Issued by Canon (UK) Limited

iR6800C-005
(F2-T01-0M3-10011-01)

Abnormal buzzing sound occurring from Intermediate Transfer Belt Assembly

P-1 Intermediate Transfer Belt Assembly

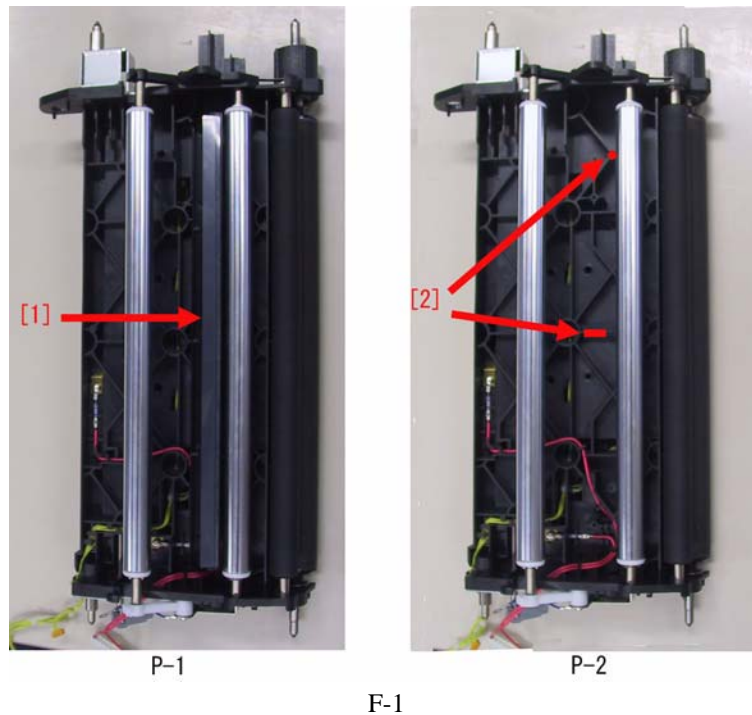
Abnormal buzzing sound occurs from the Intermediate Transfer Belt Assembly (FM2-0407).

When the edge of the Internal Scraper (FL2-0398) of the Intermediate Transfer Belt assembly is subject to adhesion of rubber residues of the rubber rollers, such as the Secondary Transfer Roller, there is an increase in the sliding frictional resistance between the Internal Scraper and the Transfer Belt, causing the scraper holder to vibrate. When the vibrating scraper holder comes into contact with the frame, a rustle occurs, leading to abnormal buzzing sound.

[1] Internal Scraper

[2] Points where the scraper holder comes into contact with the frame

A double-sided tape is applied to the points where the internal scraper holder comes into contact with the frame, so that the holder will be securely attached to the frame. This measure can prevent such vibrations of the holder as will cause an abnormal sound.

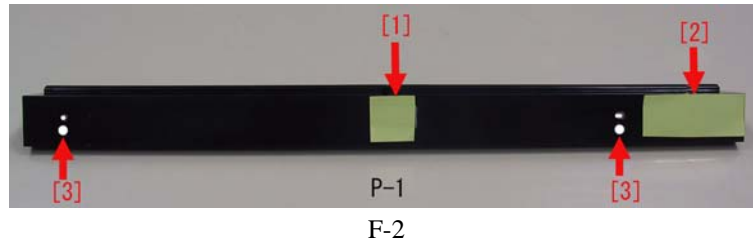
1. Remove the Intermediate Transfer Belt Assembly from the main body.
2. Remove the Internal Scraper from the Intermediate Transfer Belt Assembly, and clean it.
3. Apply a double-sided tape (20mm wide; 0.14-0.16mm thick) to the internal scraper holder, as shown below. Ensure that there is no empty space or extension of the tape at the edge of holder.
4. Release the other side of the double-sided tape, and attach the Internal Scraper.

[1] Apply a double-sided tape (20mm x 20mm) to the center of the holder.

[2] Apply a double-sided tape (20mm x 50mm) to the rear edge of the holder.
